## AIRBAG WARNING LAMP ILLUMINATED

This Service Information bulletin Replaces SI B65 18 16 **dated July 2016**.

I01 (i3)
----------

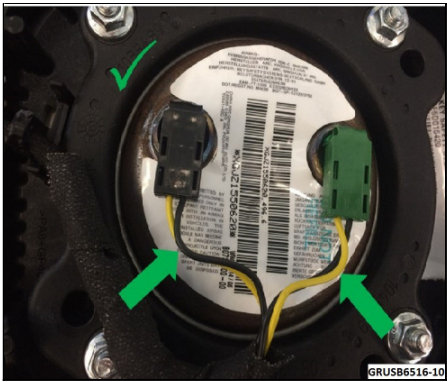
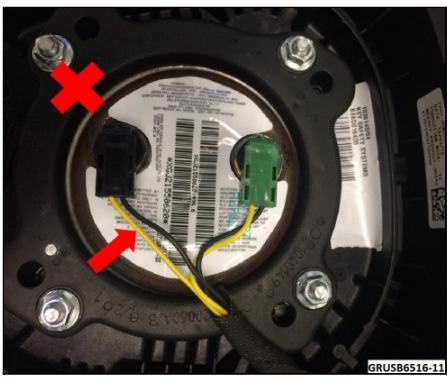
1. Run vehicle test and follow test plan for stored ACSM4 faults
2. **UPDATE!** Disconnect vehicle battery, and disconnect any battery charger prior to working on the air bag system. Check the plug connection of the steering column switch cluster (SZL). Disconnect the plug connection (yellow plug-in contact), reconnect it and check that it is securely latched into place.
3. Check for tension and tension-free routing of the wiring harness between driver airbag module and the steering column switch cluster (SZL), as shown in the photos below. Correct as needed.

Correct tension free routing
--	------------------------------

<p>Incorrect routing. The yellow wire is under tension.</p>

Replace driver's airbag module **OR** change tension on harness.
